Wiltshire Council Planning Consultation Response

Jocelyn Sage
Senior Conservation Officer
Wiltshire Council Conservation
(South/West)

Application No: **PL/2025/08707**
Tisbury Motors Ltd, High Street, Tisbury, Salisbury, SP3 6HF
The proposed development involves the demolition of the garage, flat and workshop with the erection of eight houses and associated gardens over the plot.

Proposed east elevation

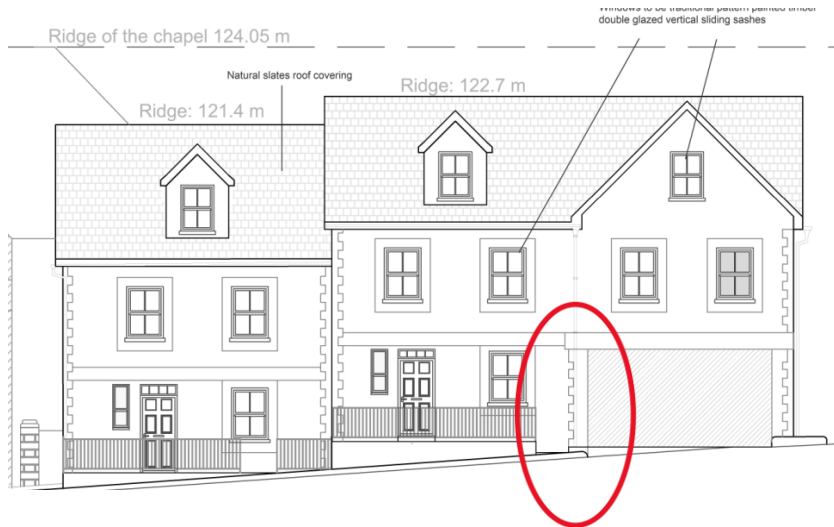
The large garage opening. If it had paired wooden plank doors it would be more traditional, or perhaps paired timber doors hung on a track?

The design of the dormers (wide ‘cheeks’);

Modern
dormer on
Beatons.
Request
dormer detail
at 1:10.

The window surrounds – not sure what this treatment is? The D&A statement says: *‘with details around doors and windows’*. Could they please elaborate?

The windows need to be larger, they are too mean. What will the cills be made of?

The small windows to the side of the door. Can’t they be larger (it screams ‘toilet’ which is precisely what it is)?;

Doors too need to be larger – more of a statement;

Is that a string course? No note on the drawing.
Could the barge boards be decorative, or at least timber?

Does the gable step forward? The ground floor plan suggests not. In which case I don't understand the quoin detail on the side of the garage opening. I would recommend a slight degree of projection so that the quoining makes sense (ie it can return round a corner). It would also mean a downpipe could nestle in the corner.

Proposed north and south elevations

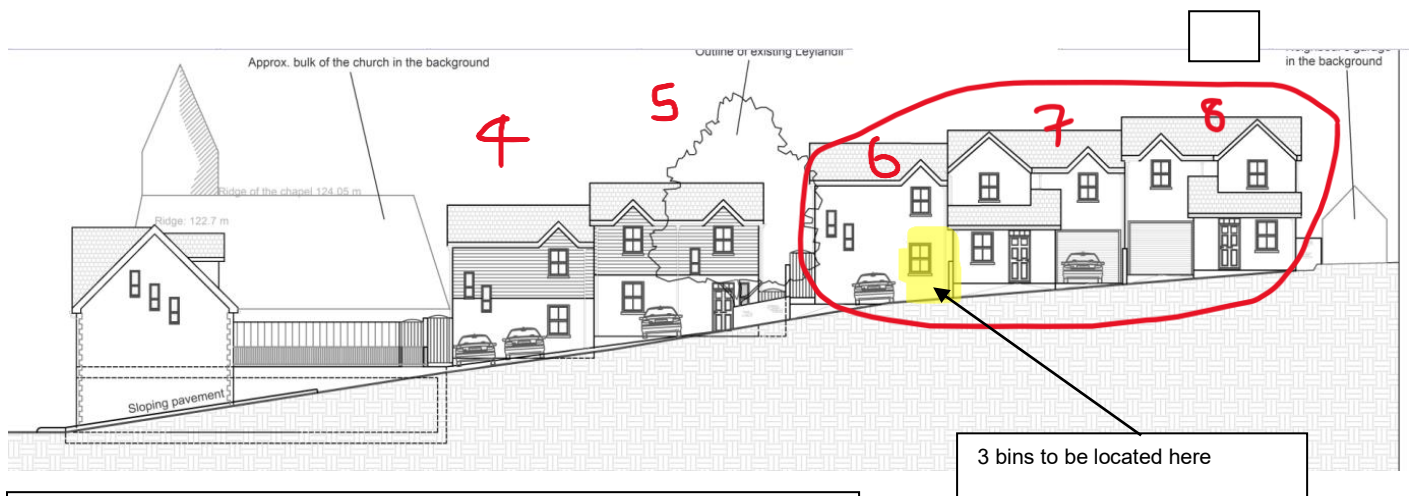
Regarding the proposed north (principal) elevations, I have reservations about the scale of the most westerly three units (units 6-8). Historically buildings tend to diminish in scale as they retreat into the plot. The lane rises upwards from the street, as such, the two storey units will be over-bearing. My view is that three (or preferably one or two) one and a half storey chalet bungalows would be preferable.

Integrated garages with up and over garage doors do not reflect the local vernacular.

Pokey single 'stair' windows on the gable end;

Sash windows which are too small;

Absence of front door on lower house. Could the layout not be reconfigured to provide a more convincing terrace character?;

Doors need to be more of statement ie timber surround and perhaps flat roofed porch? Also, I note that the proposed door for unit 6 is on the side. As such, the elevation is 'uninspiring' (it is presumably because the two car parking spaces are directly in front of the house walls). The gable 'feature' is also underwhelming;

Use of horizontal cedar cladding. This isn't a material that features strongly in the conservation area. I would recommend that this is reconsidered.

Bins: I notice proposed no 7 has the bins in front of the house and in front of a window. I recommend this is reconsidered (if there were two units, there would be more scope).

In design terms, it doesn't look particularly traditional and the choice of timber cladding, not characteristic of the CA. I wonder about brick and tiles for some variety? A coloured CGI of this 'lane view' would help.
